Addendum #3
Lakeland School Corporation
Maintenance Building

Date: May 1st, 2026
Project: Maintenance Building
Project #: 25082
Pages: 1 of 4 (8-1/2x11) pages
Bid Dates: **THURSDAY, May 14th, 2026 at 11:30 am (prevailing local time)**

5 Electrical Riser Diagram 1

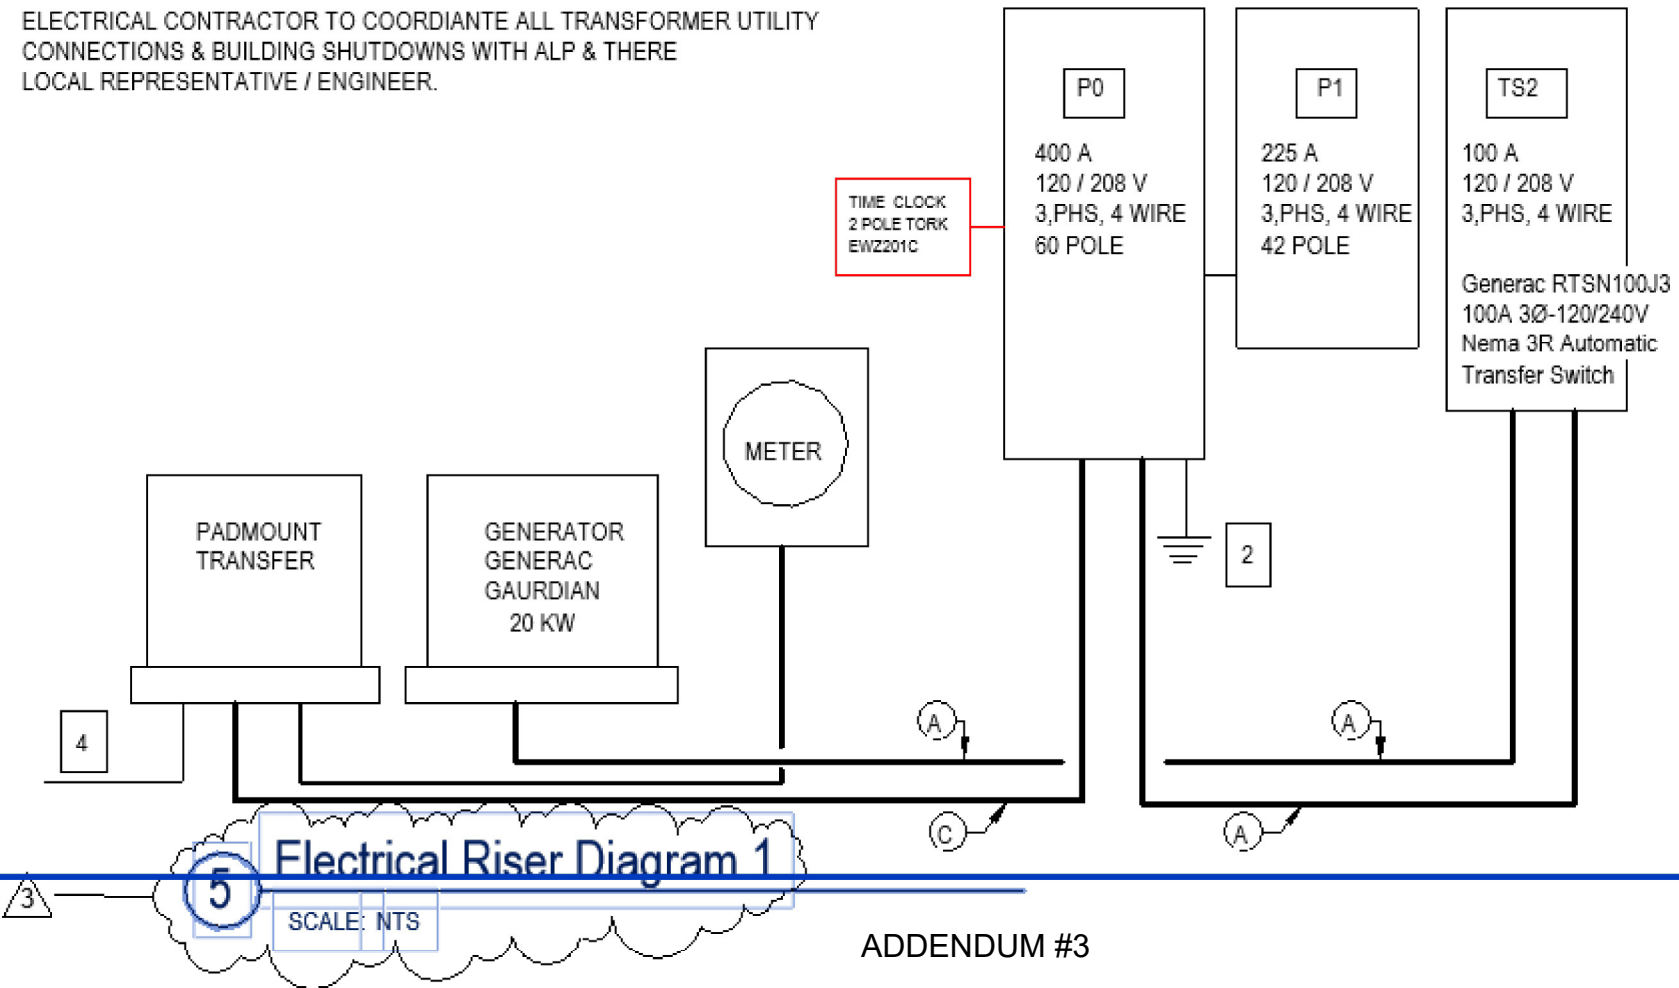
5. Yes its acceptable to run Branch circuits under slab in NMC/PVC with GRC through slab penetrations.
6. See revised Electrical Riser Diagram.
7. Removing Mezzanine Unit 2 from the project. There will be no outdoor HP / Condenser C2 and no disconnect,

TYPICAL BACKFLOW PREVENTER WTR. METER SETTING ARRANGEMENT

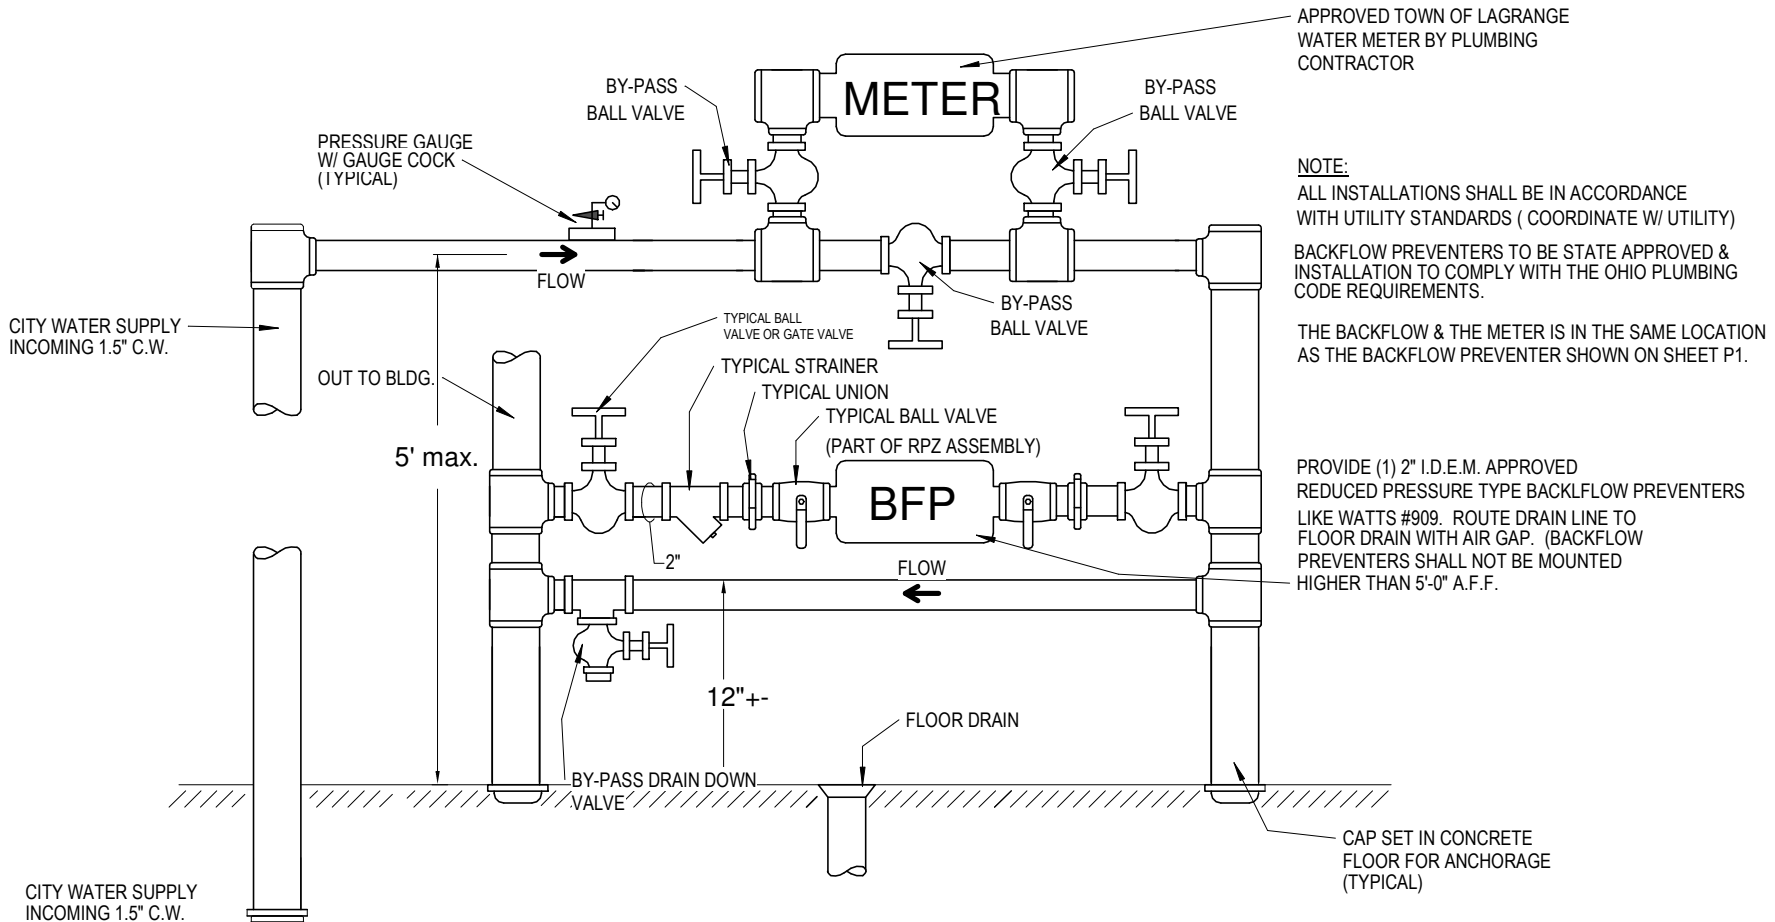
1. Grease interceptor, HVAC unit, electric and gas meters all say "by others" Grease interceptor, HVAC unit by MEP Contractor. Gas meter by gas company. 1.5" Water Meter Provided by Town of LaGrange Water Department (INTERIOR INSTALLATION BY PC) . See detail this addendum. INSTALLATION of the WATER METER BY PC.
2. Mezzanine Unit 2, remove from the project. No condensate line, Gas line, or floor drain from the mezzanine.
3. Waterline copper piping, Type K copper to be used underground, Type L to be used aboveground.
4. PEX piping is not approved for the project.

PROVIDE (1) 2" I.D.E.M. APPROVED
REDUCED PRESSURE TYPE BACKFLOW PREVENTERS
LIKE WATTS #909. ROUTE DRAIN LINE TO
FLOOR DRAIN WITH AIR GAP. (BACKFLOW
PREVENTERS SHALL NOT BE MOUNTED
HIGHER THAN 5'-0" A.F.F.

2 4-MEZZANINE ELECTRICAL REFLECTED CEILING PLAN
SCALE: 1/8" = 1'-0"

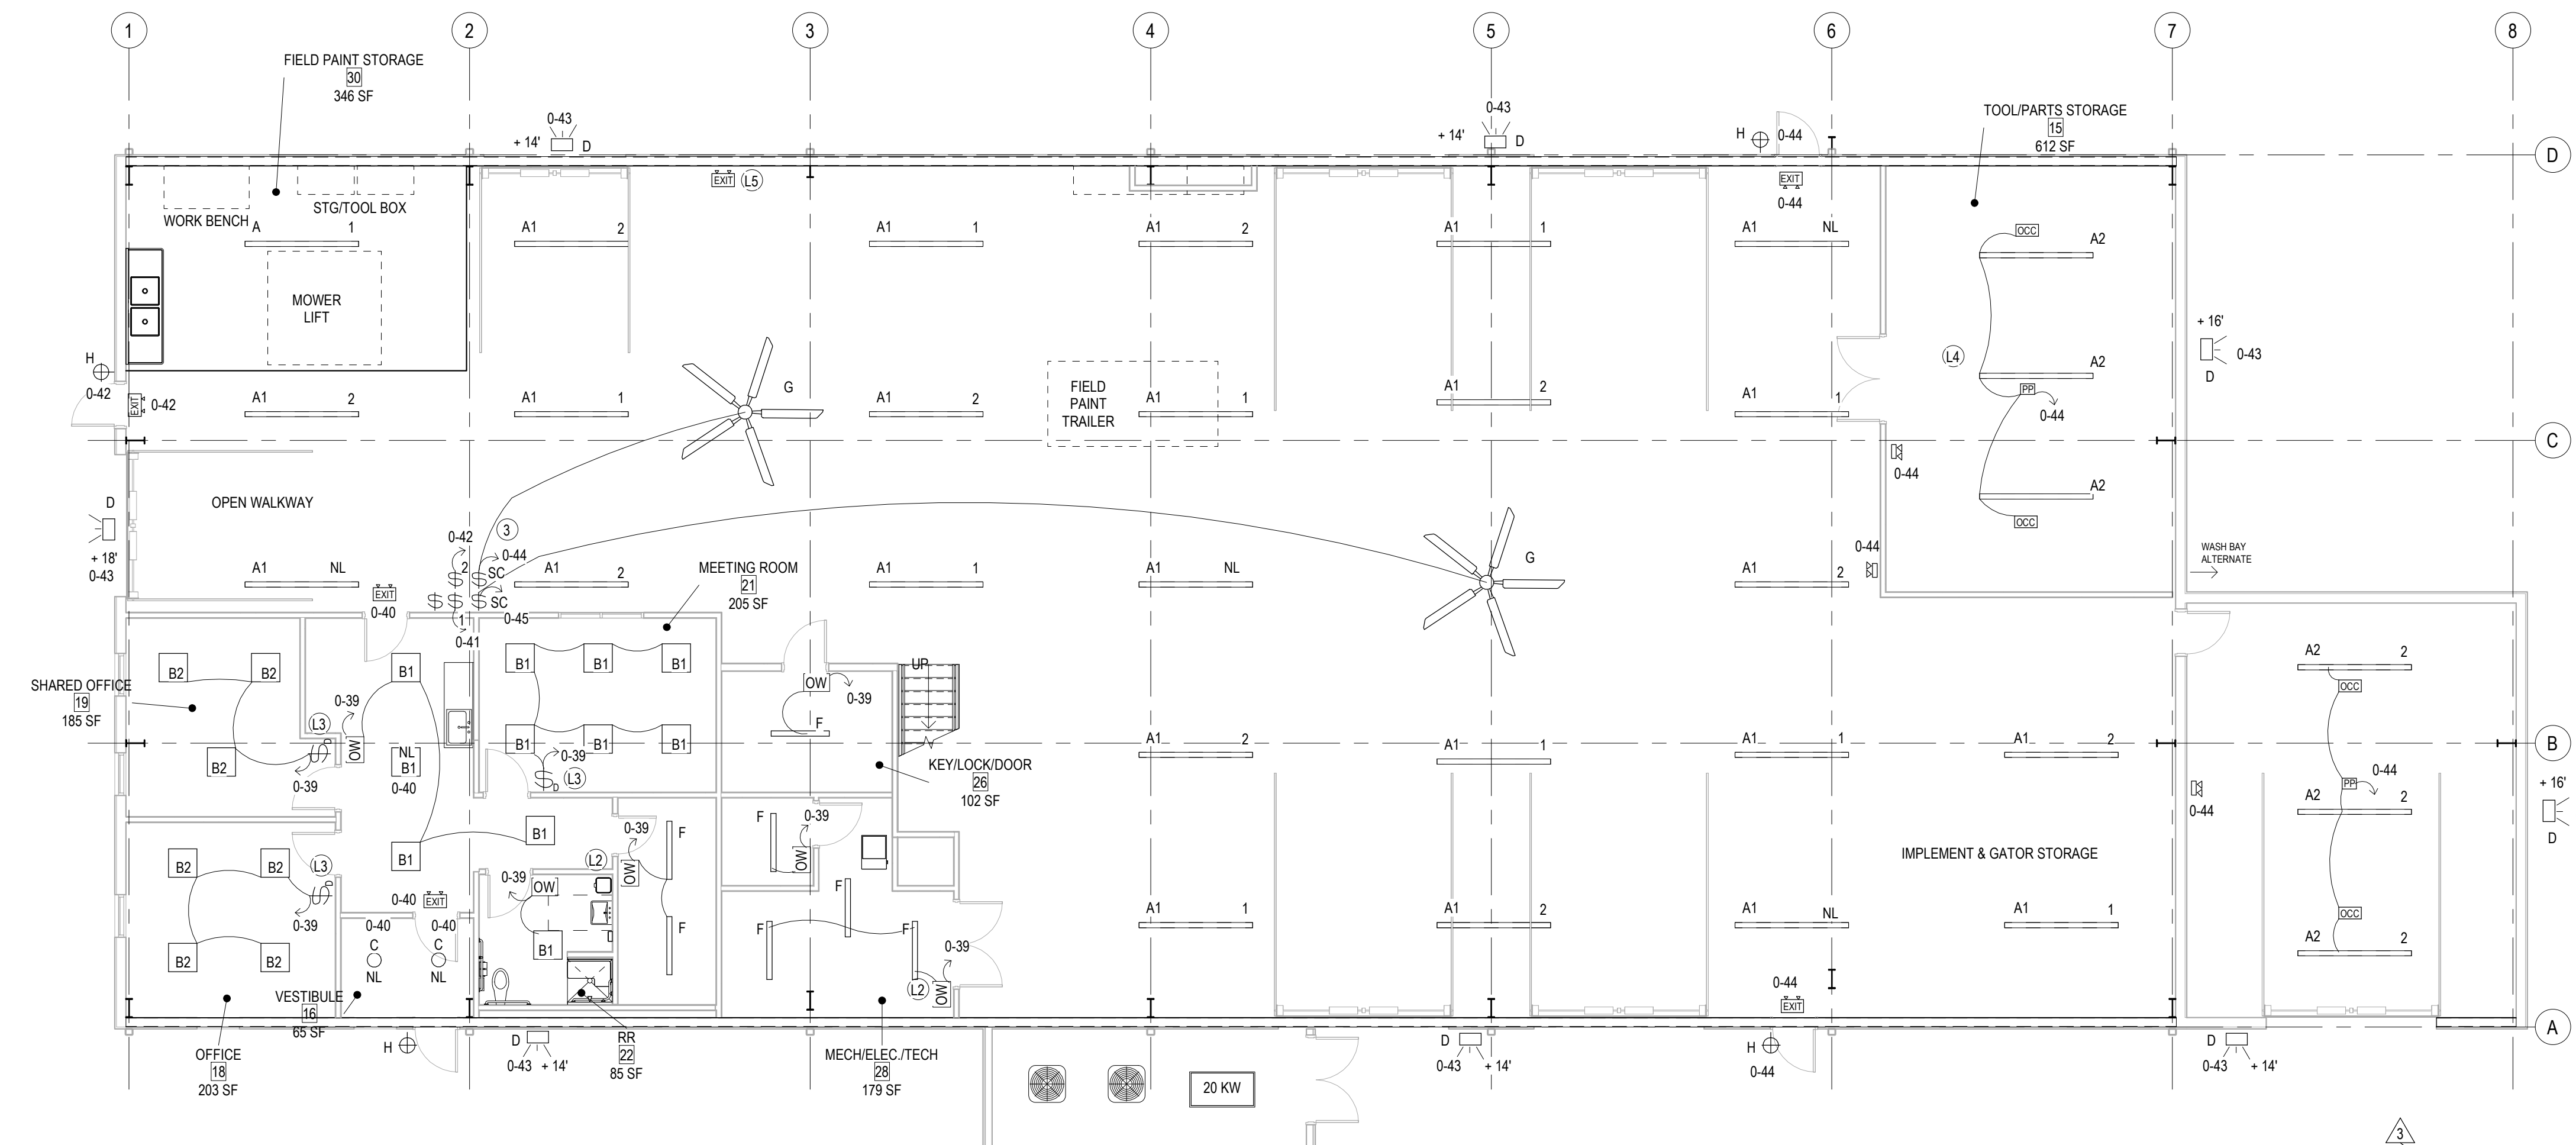
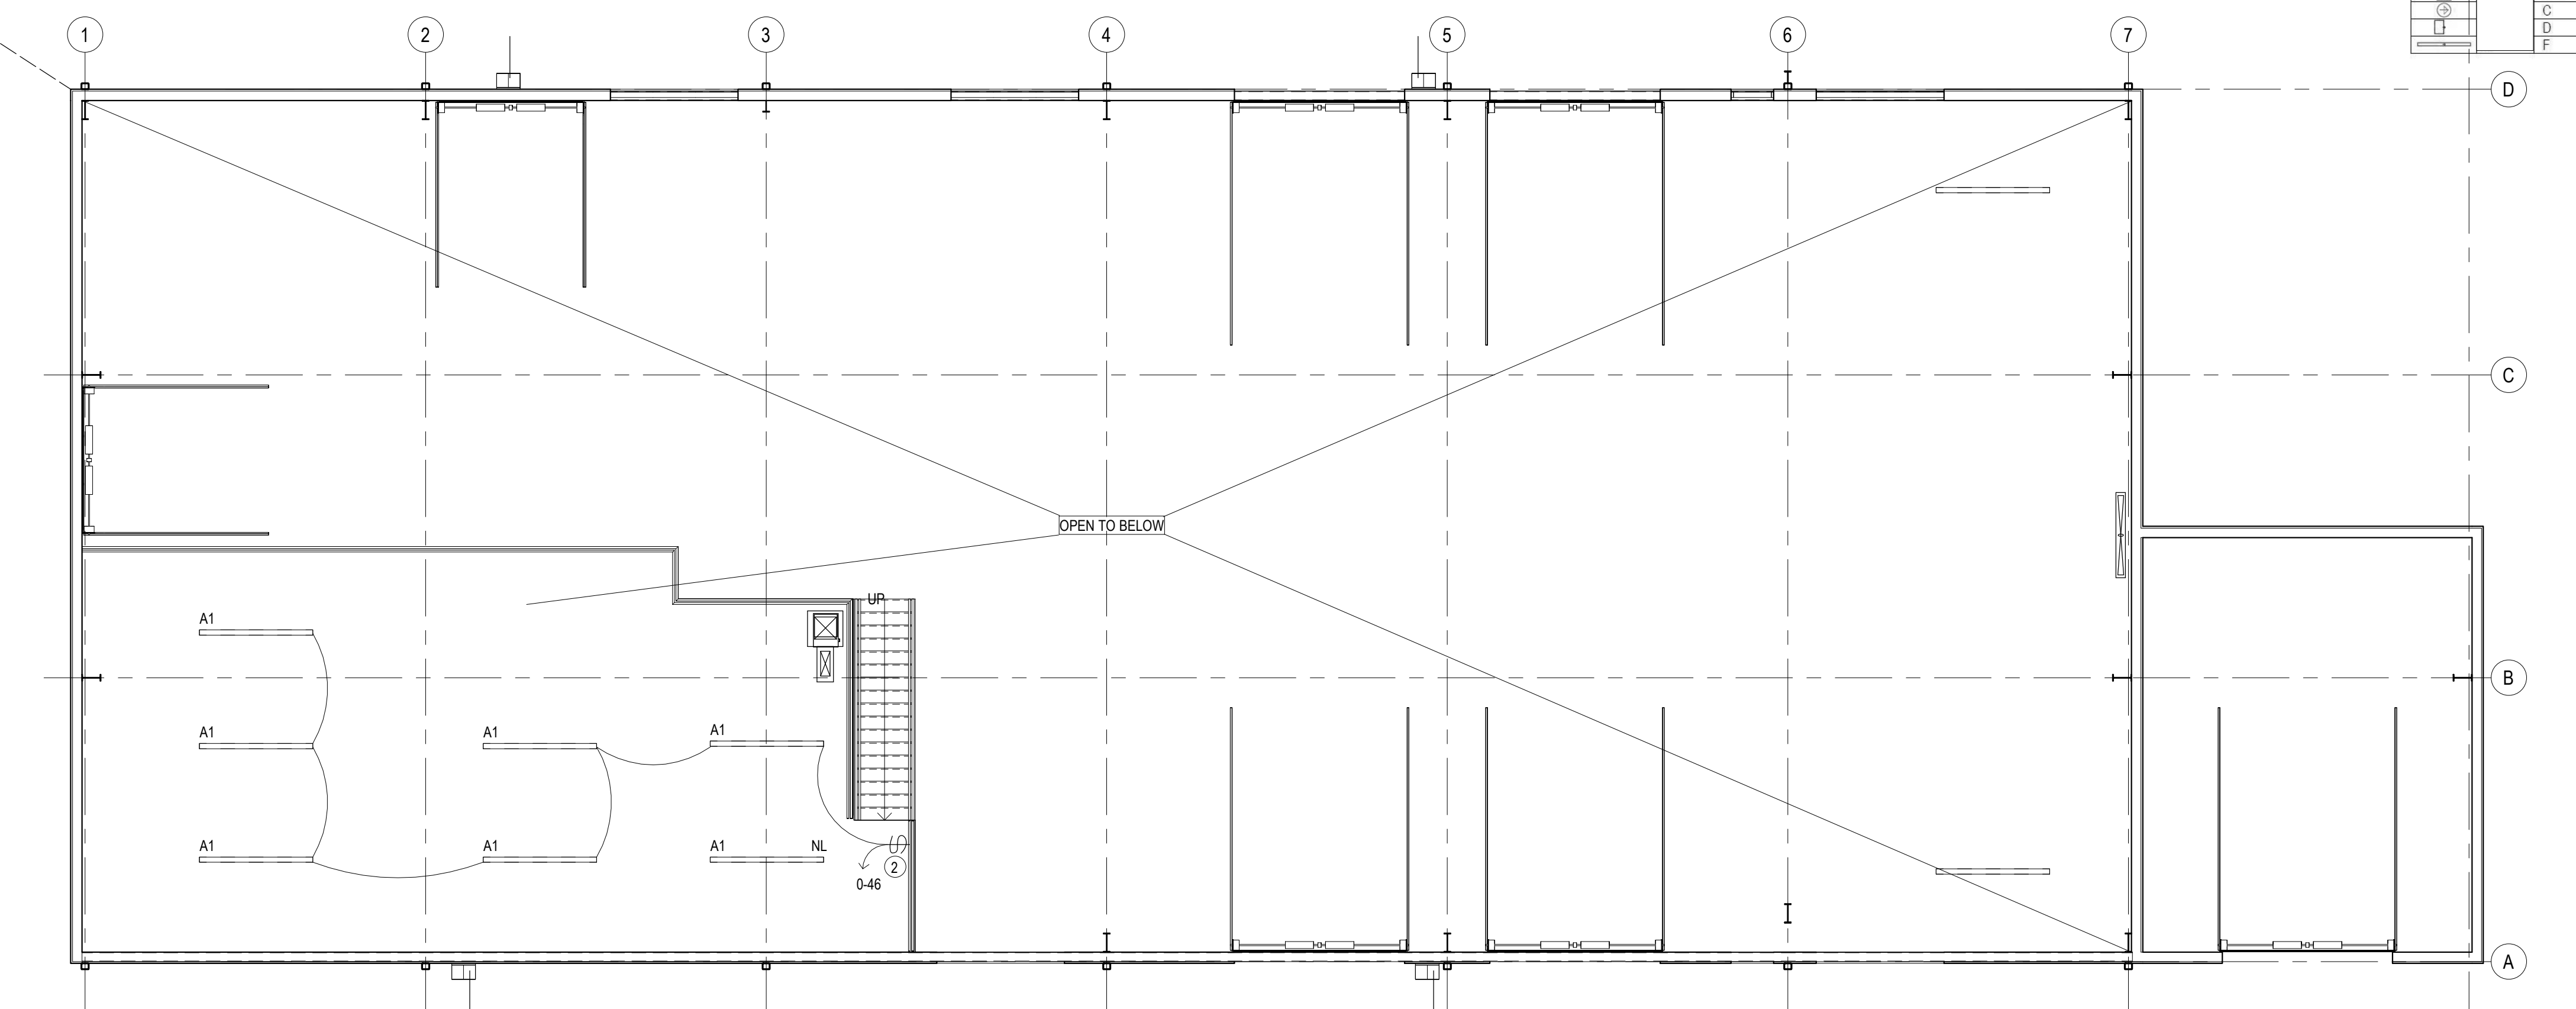
1. The switches referenced by note #3 are not dimmers. There are 2 fan speed controls.
2. The 10' diameter ceiling fans to be Hunter ECO HVLS FAN CONTROL THRU HUNTER 350 SERIES CONTROLLERS.

- ① ALL OCCUPANCY SENSOR TO BE SET TO TURN OFF LIGHTS LESS THAN 30 MINUTES AFTER ANYBODY LEAVES THE ROOM.
- ② EMERGENCY LIGHTS OR EMERGENCY LIGHT FIXTURES TO HAVE EMERGENCY BALLASTS WIRE FOR NON SWITCHING OPERATION.
- ③ EXACT LOCATION OF THIS BANK OF LIGHTS DIMMERS TO BE BY OWNER. 2 LOCATIONS.
- ④ UL 924 DEVICE REQUIRED AT LED FIXTURES WHEN USED AS EM & ALSO USED AS DIMMABLE FIXTURES.
- ⑤ NIGHT LIGHTS TO BE ON NON SWITCHING LEG OF CIRCUIT.
- ⑥ EXTERIOR LIGHTS TO BE CONTROLLED BY TIME CLOCK.
- ⑦ THE A1 & A2, FIXTURE HEIGHTS VARY. A1 & A2, TO HAVE 36" LONG STEMS. FIELD CUT OPTION FOR STEMS TO 32". STEMS TO BE 36" LONG BUT CUT TO 32" MOUNT TO BTM. OF ROOF DECK.
- ⑧ TYPE A1 FIXTURES IN MEZZANINE TO BE MOUNTED TO BTM. SIDE OF ROOF PURLINS.
- ⑨ BOTTOM OF 10' CEILING FANS TO BE 14' AFF. PROVIDE 5' EXTENSION ROD & 2 EXTENSION ROD. CONTROL THRU HUNTER 350 SERIES CONTROLLERS.
